**TRANSMITTAL OF MEETING HANDOUT MATERIALS FOR
IMMEDIATE PLACEMENT IN THE PUBLIC DOMAIN**

Docket Number(s)	<u>05000498 & 05000499</u>
Plant/Facility Name	<u>South Texas Project, Units 1 and 2</u>
TAC Number(s) (if available)	<u>MA6057 and MA6058</u>
Reference Meeting Notice	<u>2000-0299</u>
Purpose of Meeting (copy from meeting notice)	<u>Discuss the details of the licensee's process for risk ranking</u> <u>components as it relates to the risk-informed multipart</u> <u>exemption request to the special treatment req in 10 CFR Part 50</u>

U.S. Nuclear Regulatory Commission
and
STP Nuclear Operating Company
Meeting on
Risk-Categorization Process for
Exemption from Special Treatment Requirements

STP/NRC Working Group Meeting to Address GQA Process-Related Questions and Responses to the RAI's

Figure 1: Diagram of Categorization and Treatment

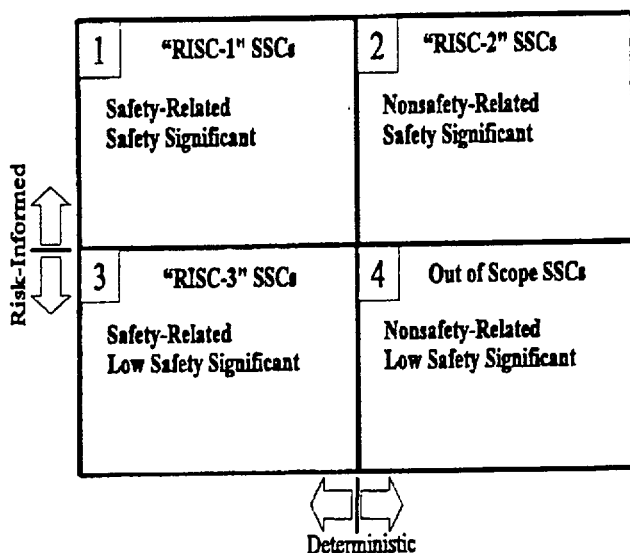
- In SECY-99-256, "Rulemaking Plan for Risk-Informing Special Treatment Requirements," the NRC staff describes a scheme for categorizing SSCs according to their safety significance and status under the deterministic safety-related regime. This scheme divides SSCs into 4 bins. (See Figure 1.) Risk-informed safety class 1, or RISC-1 SSCs are presently safety-related and are determined to be safety significant by a risk-informed categorization process. RISC-2 SSCs are not presently safety-related, but have been determined to be safety significant by a risk-informed categorization process. RISC-3 SSCs are presently safety-related, but have been found to be of low safety significance by a risk-informed categorization process. Remaining SSCs are expected to be out of the scope of special treatment requirements, though other regulatory controls may still apply.

In an effort to equate current Risk-informed Rulemaking efforts with your exemption request, please describe how the STP risk categorizations compare to these classifications.

NO regulatory controls have been applied to these non-safety-related, LOW and NRS categorized components, and upon grant of the Exemption, no regulatory controls would be added. Components in this category would still receive appropriate administrative controls to give reasonable assurance that these components will perform efficiently and reliably. The components whose additional controls are NONE equate directly to the proposed RISC-4 box, 'non-safety-related, low safety significant'.
